Register Reference: SD22A/0300 AI
Development: 2 storey, 2 bedroom, end of terrace house to side of existing dwelling; a new vehicular access from Kilcarberry Close; all related works.
Location: 5, Kilcarberry Close, Clondalkin, Dublin 22.
Applicant: Robert Flanagan
App. Type: Permission
Planning Officer: SARAH WATSON
Date Received: 28-Oct-2022
Decision Due: 24-Nov-2022

Roads Department Assessment:

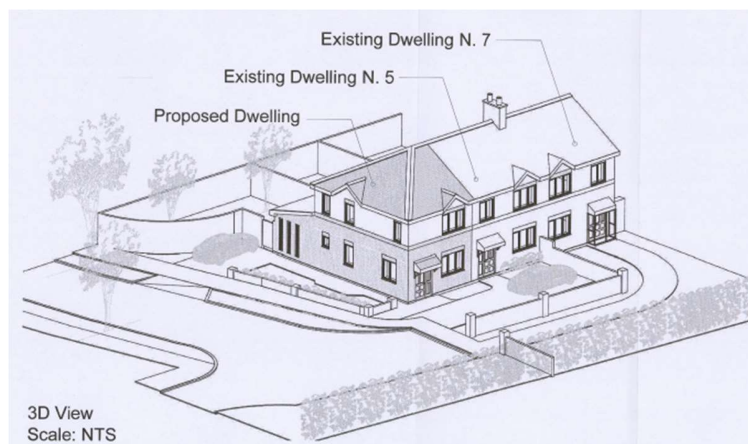
1. The applicant is requested to submit:
 - a. A road safety audit (level 1) which includes AutoTRAK analysis is required which addresses issues of vehicular egress from dwellings No.5 and No.7, taking into account pedestrian safety and the swept paths of vehicles.

- b. A revised drawing to be submitted with the provision of a visibility splay in both directions from the side entrance that meets the minimum requirements for the 30km/h zone.

2. The applicant is requested to examine alternative provision of access / parking that:
 - Result in more usable rear amenity space
 - Meet the requirement of the Roads Department

- Protect existing Green Infrastructure.
3. It is noted that the proposed changes to the car parking for the existing dwelling are located outside the redline for the proposed development. The Roads Department has raised concerns regarding safety and has requested an audit, which may result in the omission of the proposed change of car parking to the front of No5. However, should the revised car parking remain, the applicant is requested to submit a revised site layout plan, which includes the impacted area within the redline.

It must be noted that existing vehicular access from properties No.5 and No.7 are not affected by the proposed dwelling. It is only the parking location to the front of property No.5 that is changed. A swept path analysis is provided with drawing reference 5KC-PD03.

The owner of property No.7 has recently built garden walls around the property front driveway. The walls were not present at the time of our original survey. The walls are now added to our drawings. The vehicular access to Property No.7 constrains the user to a long reversing manoeuvre when leaving the dwelling; however, this issue is not related to the proposed dwelling. It is an existing context. The proposal to lower the side boundary wall will increase visibility for a car reversing out of property No.7, offering a safer setting.

The vehicular access to existing Property No.5 is preserved without changes. It is only the car parking location that is modified and permeable paving proposed. The proposal to lower the side boundary wall will increase visibility for a car reversing out of property No.5, offering a safer setting.

The parking area for the proposed dwelling was revised along with the proposed landscaping submitted with drawing reference 5KC-PD02. Lowering the side boundary wall offers safe visibility on the footpath and on the road. The revised proposal offers a safe setting for cars leaving the site. The setting for properties at No. 1 and No.3 have 2 meter high boundary walls on the sides of the driveways, causing a hazard for pedestrians using the public footpath due to poor visibility for cars exiting the driveways. The revised vehicular access for the proposed property offers a safer level of visibility than the one provided for these existing adjacent properties.

Changes are proposed in the rear garden for the existing dwelling and changes are also proposed to the front of the existing dwelling, as the existing concrete slab is removed for the inclusion of permeable paving and the relocation of the parking area. We have now included the full site in the red outline as minor changes will also occur in the existing house roof that will be tied to the proposed dwelling roof.
